SEWAGE SYSTEM REPAIR
SEWAGE REPAIR-REPLACE BROKEN TANK & ADD LATERAL

· Permit # 99390062901

Individual Sewage Disposal System
Application to Alter, Extend or Repair

REAL ESTATE TRANSFER/LOAN APPROVAL FORM

As Built Drawing

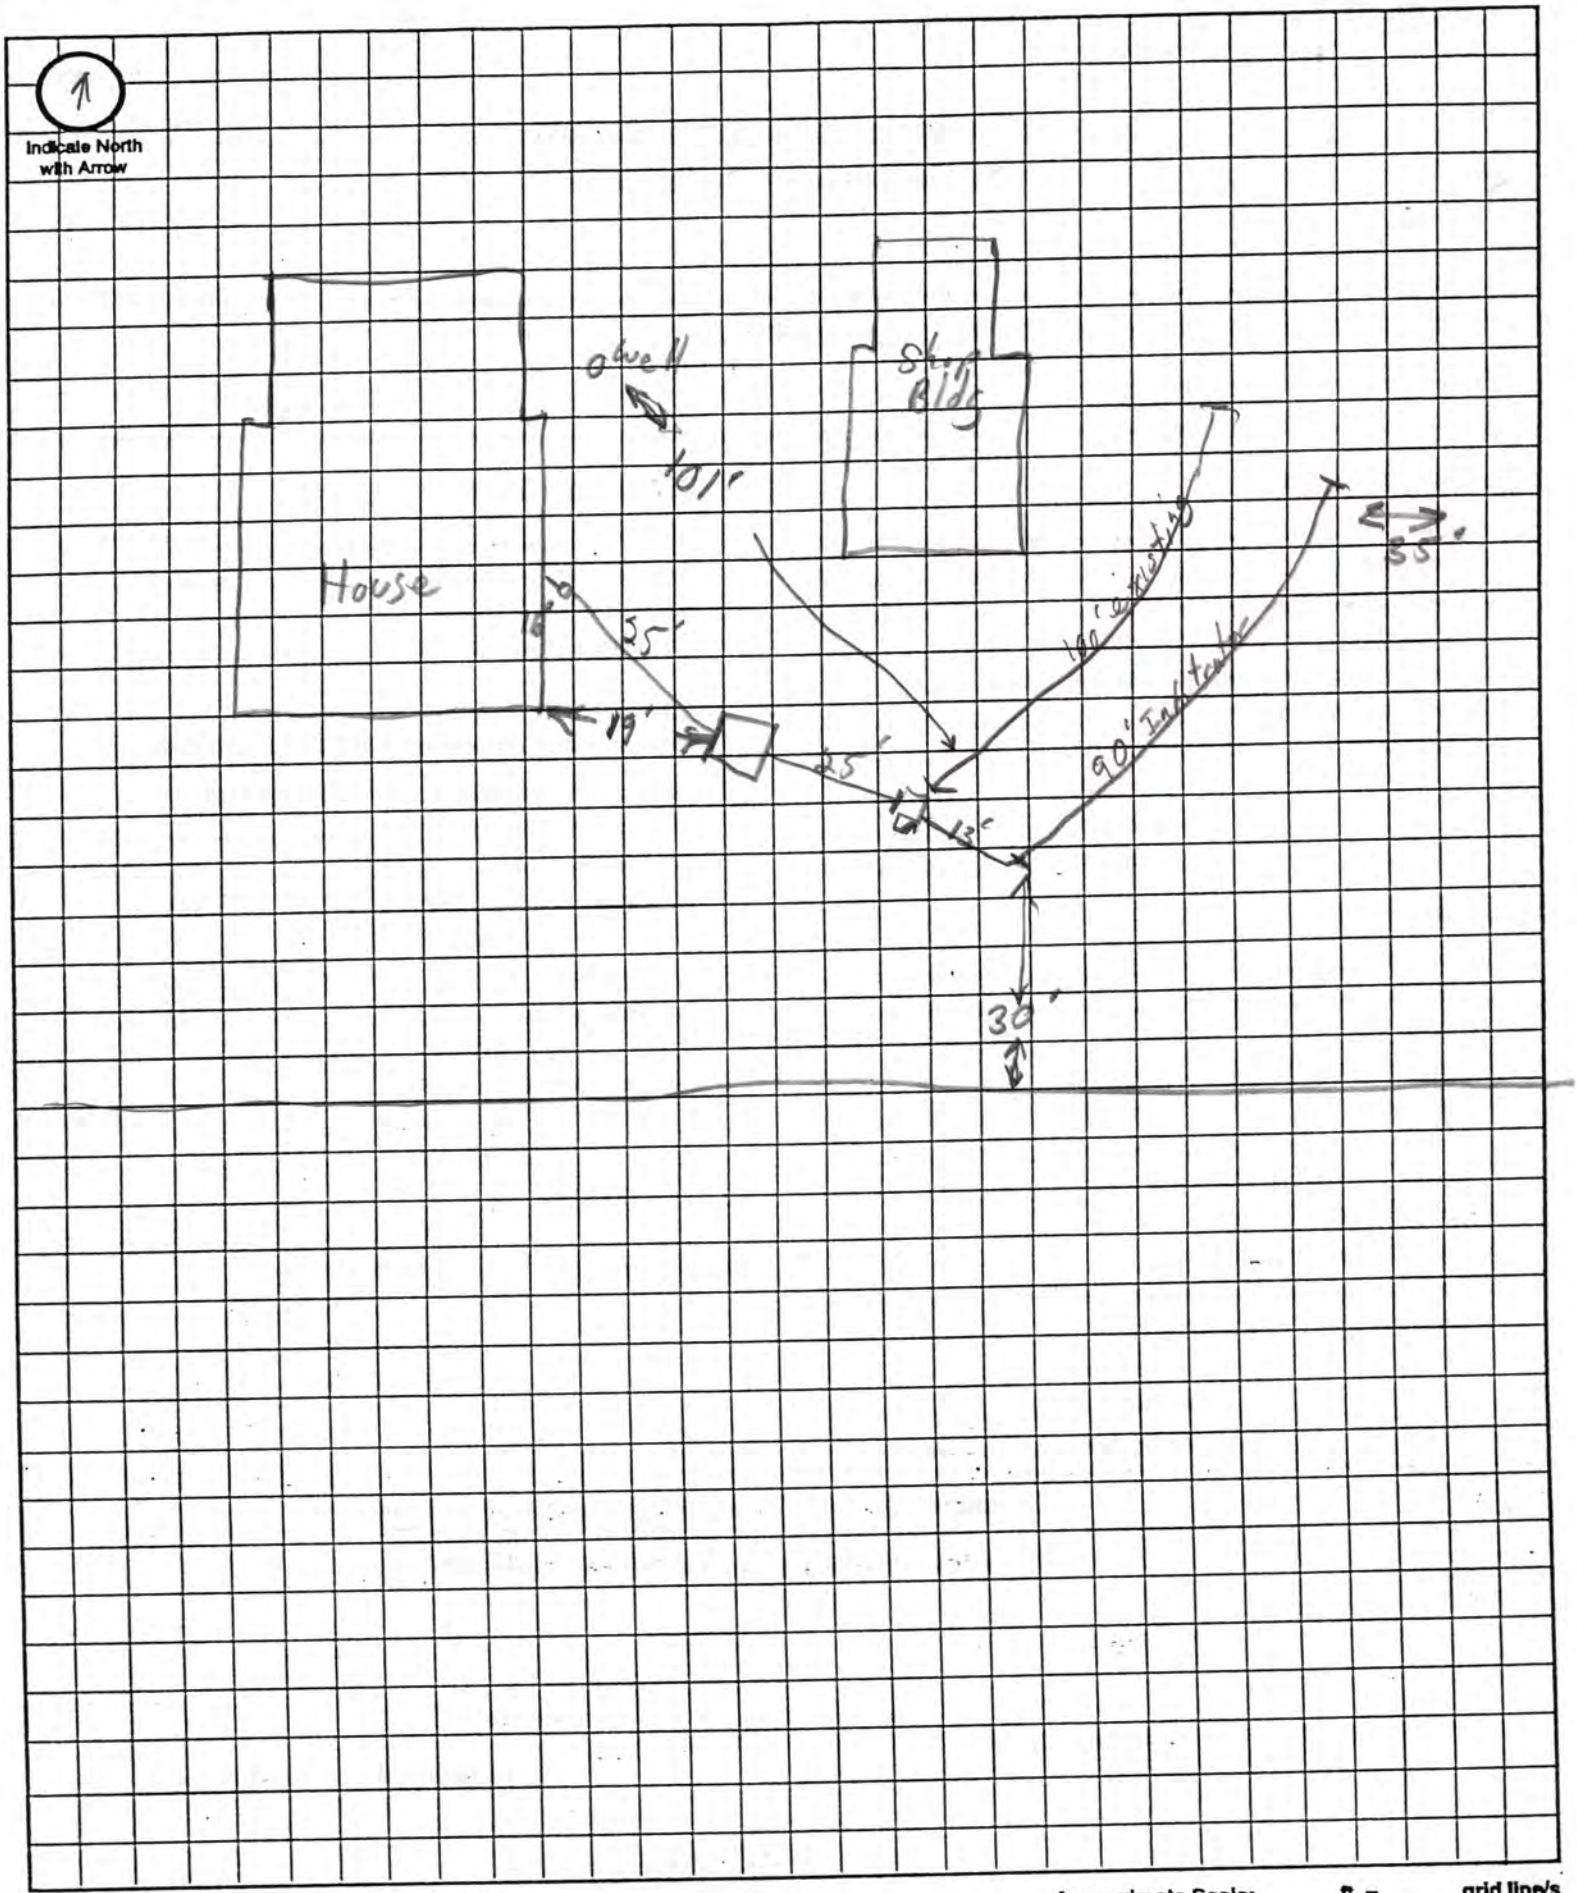
1. Type: ☒ Half rounds ☒ Perforated pipe
   Diameter of half round: 12"
   or perforated pipe: 4"
   Material: ☐ fiberglass ☒ plastic ☐ concrete
   ☐ other _____
2. Lateral lines: Number 2
   Length of each line: 100 ft. 90 ft.
   _____ ft. _____ ft., _____ ft.
3. Trench dimensions: Width 3' +4' ft.
   Slope 3 in/100 ft.
   Average depth 40 in
4. Filter material: Road Gravel
   Depth of material 18 in.
5. Distances to: Well or suction line > 100' ft.
   Stream > 50' ft.
   Pressure line > 30' ft.
   Property line > 20' ft.

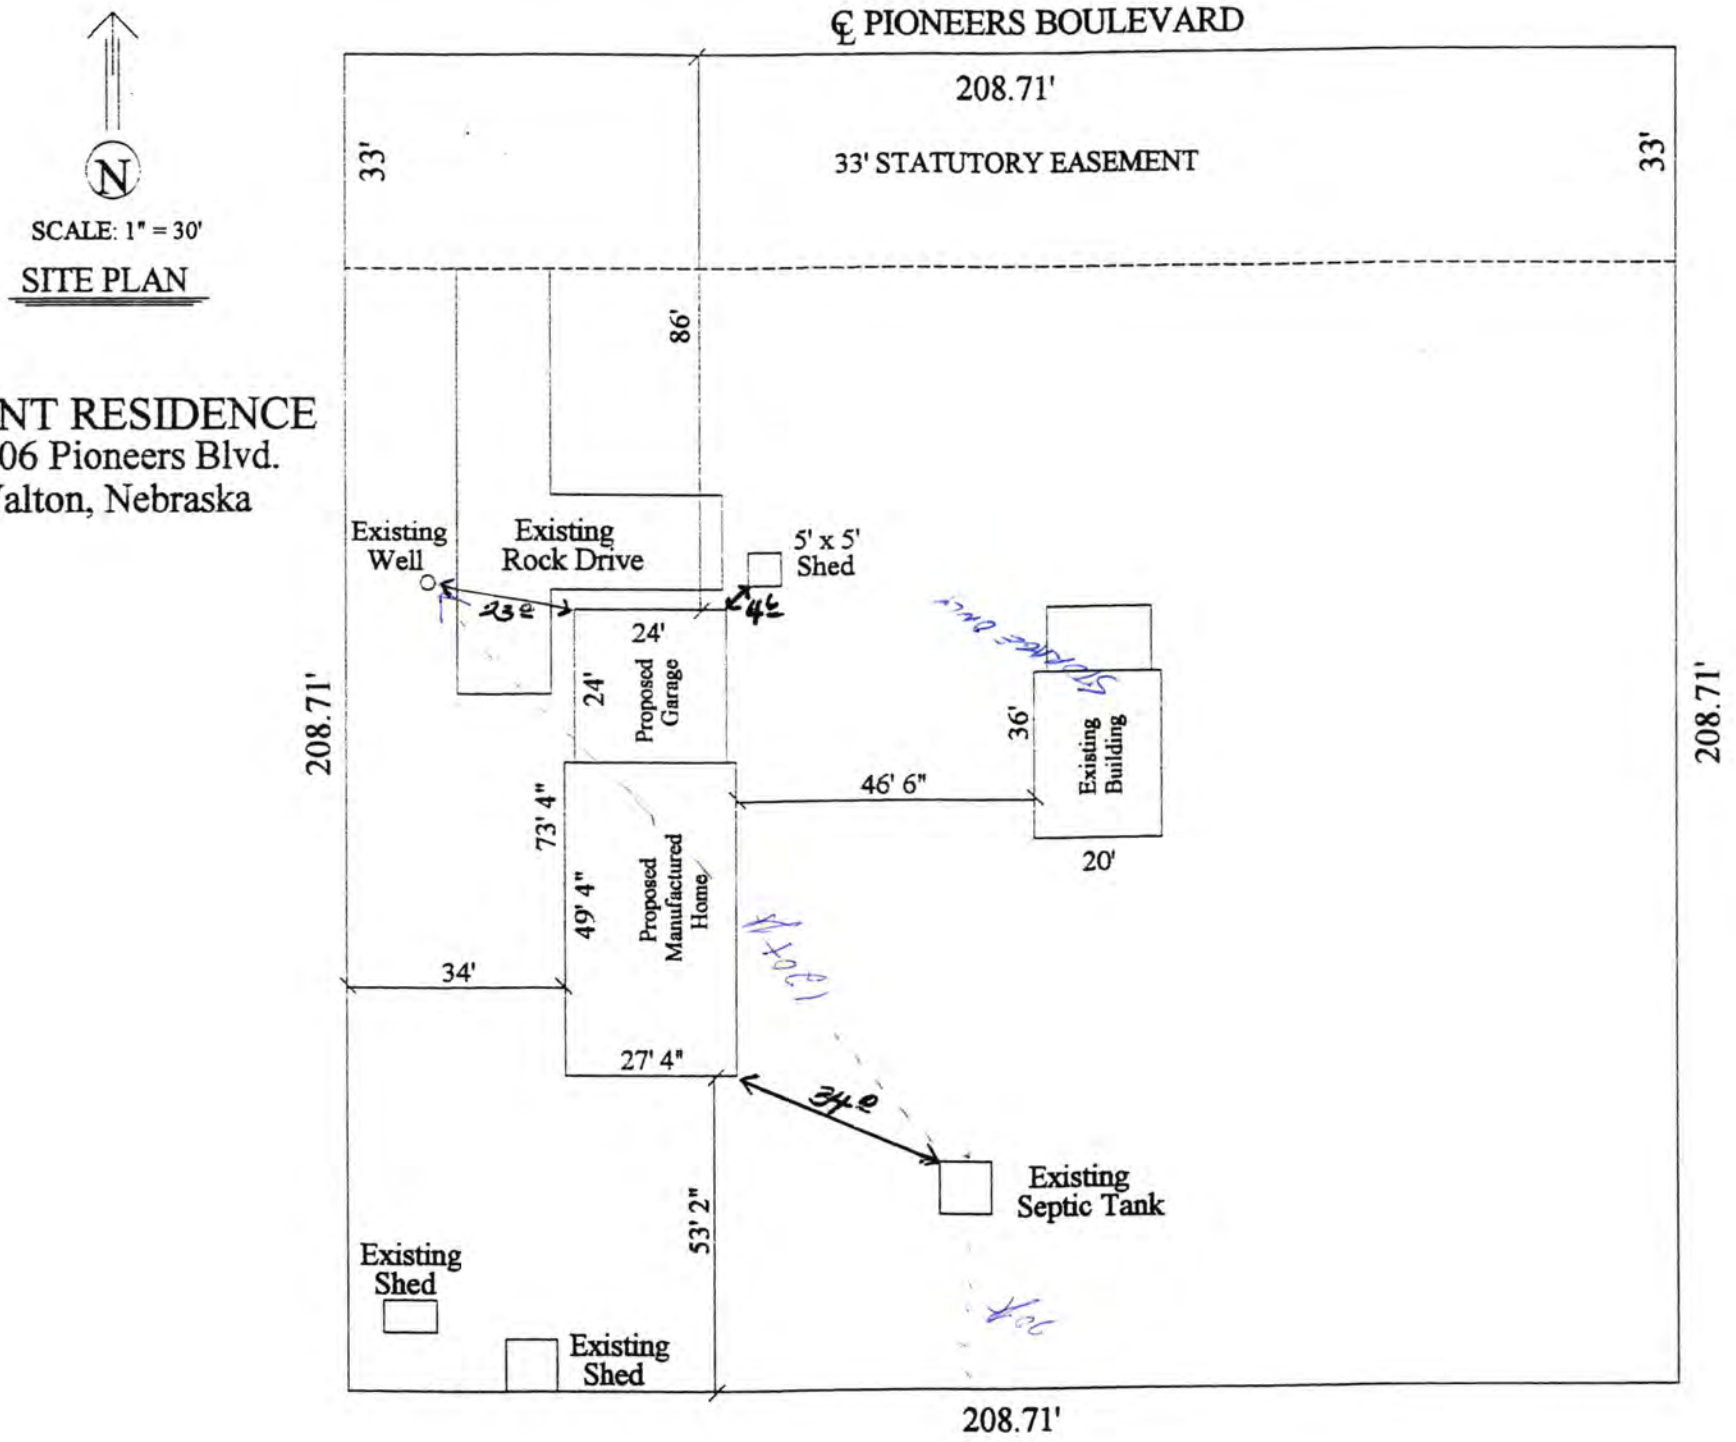
Comments: SEWAGE SYSTEM IS LEAKING. COMPONENTS OF SEPTIC SYSTEM ARE TOO CLOSE TO WELL. BROKEN CONCRETE FLOOR IN WELL HOUSE SHOULD BE REMOVED AND PATCHED. See Attached Letter ☐

7/21/95 Sewage system is not based off of soil percolation tests. L.C.H.

WATER SYSTEM: Approved: ☒ **SEWAGE DISPOSAL SYSTEM** Approved: ☐ Provisional Approval: ☒
